Re: Condition Survey of Existing Masonry Walls
at 907 Congress, 909 Congress, and 911 Congress

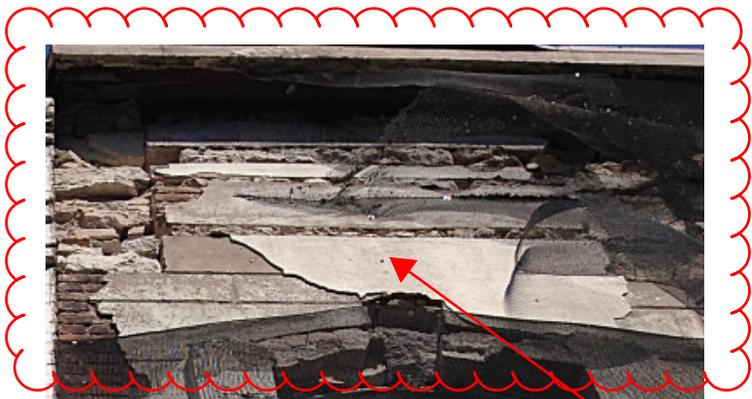
Failed Masonry
At Roof

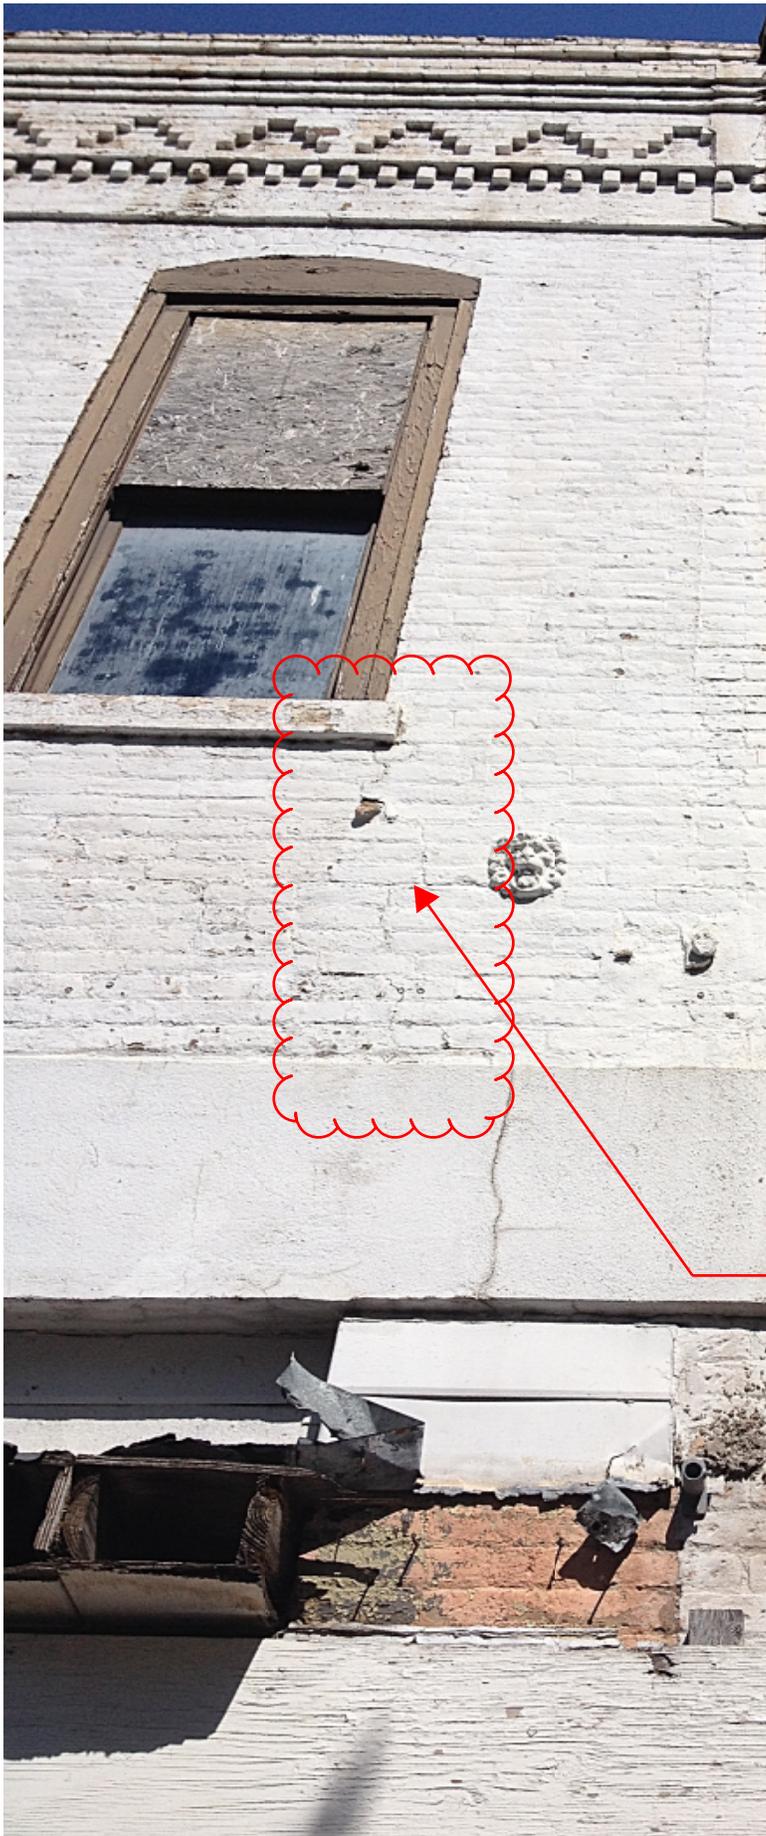
Failed Masonry

Shear Crack
Through Masonry

Failed Masonry

Failed Masonry
On Lower Level
